**TITLE**: **SPECIAL PERMIT NO. 11023,** requested by R.I.P., Inc., for authority to develop the **Magic Hills Community Unit Plan** consisting of 96 dwelling units in four buildings and a clubhouse, on property generally located at North 24th Street and Dodge Street.

## LINCOLN CITY/LANCASTER COUNTY PLANNING STAFF REPORT

**PROJECT #:** Special Permit No.11023

MAGIC HILLS
COMMUNITY UNIT PLAN SPECIAL PERMIT #_____
LINCOLN, NEBRASKA

SITE PLAN

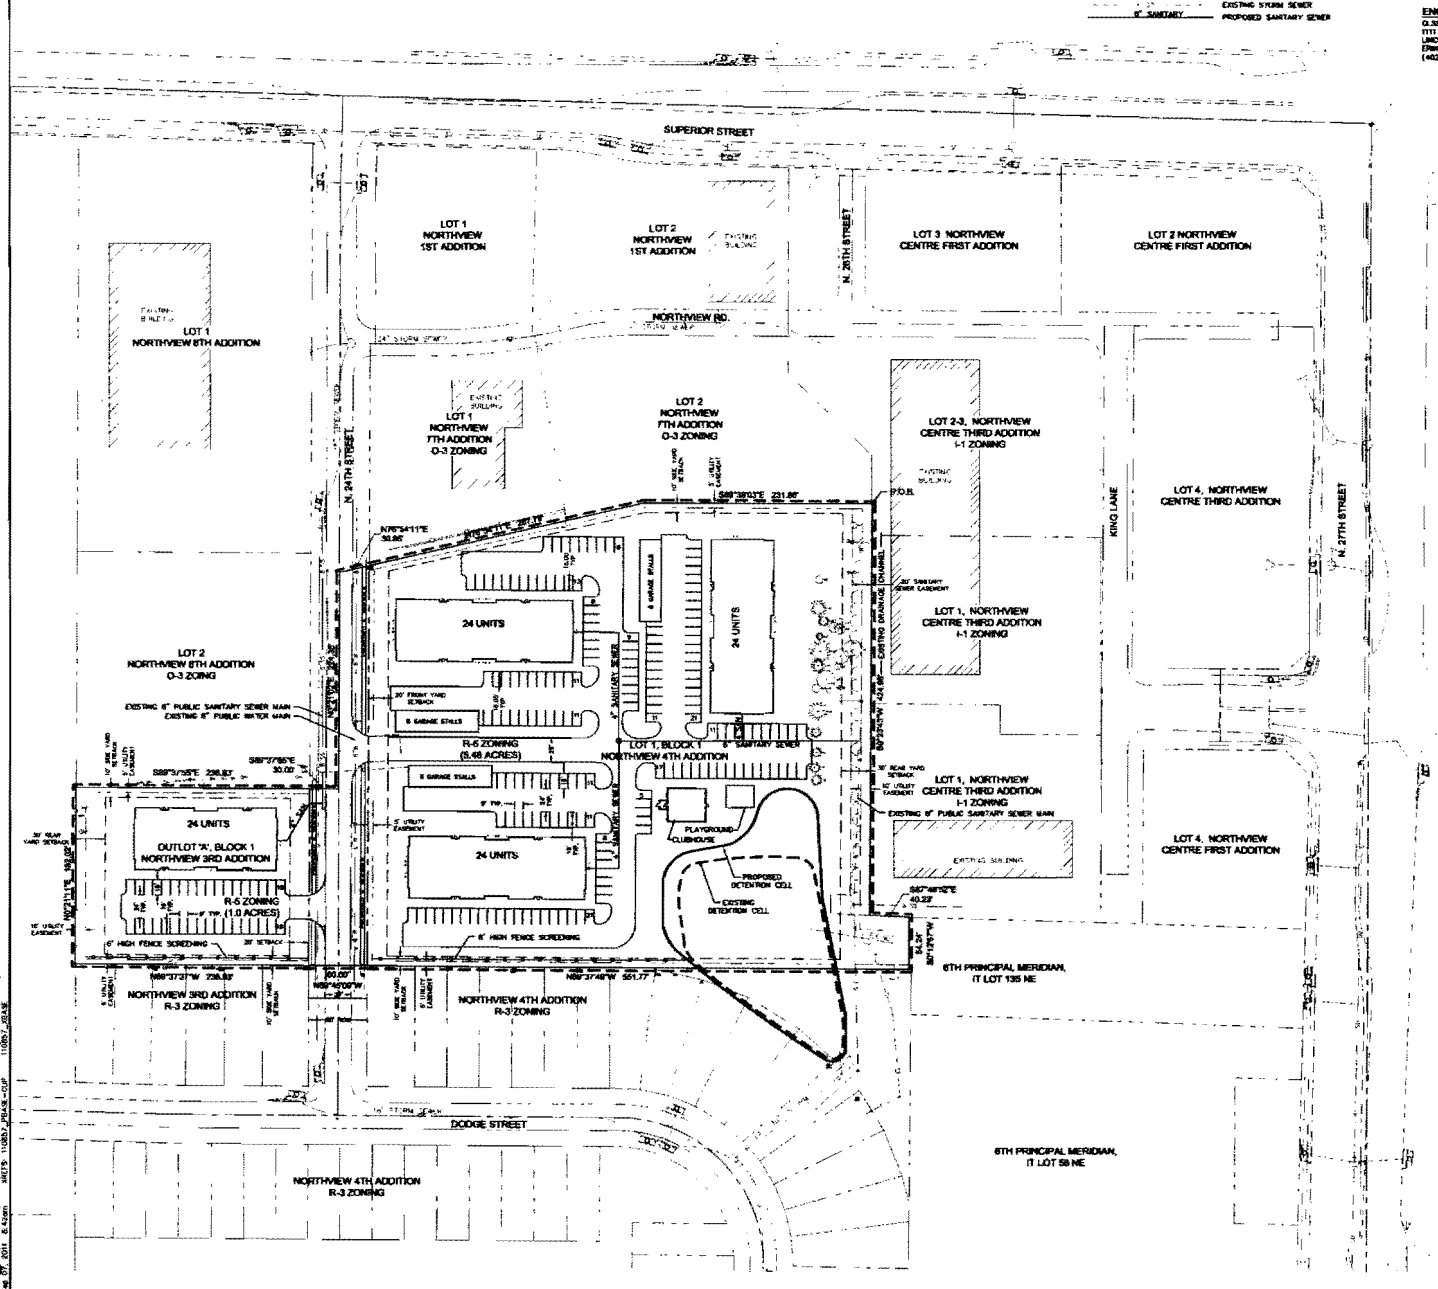
2.1 In the Site information table change the required parking to 192.

2.2 Delete note #10 in the General Site Notes

2.3 Show a detail of the playground and the type of equipment within the playground.

2.4 On the south property line show a 40 foot building setback and a 15 foot parking setback.

2.5 On Lot 1, Block 1 change R-5 to R-4.

2.6 Delete "change of zone" from the legal description.

2.7 Remove the landscaping on the east side if it is not intended to remain. If it is to remain add a note stating landscaping to remain.

2.8 The special permit is final action at Planning Commission. Remove the City Council approval block.
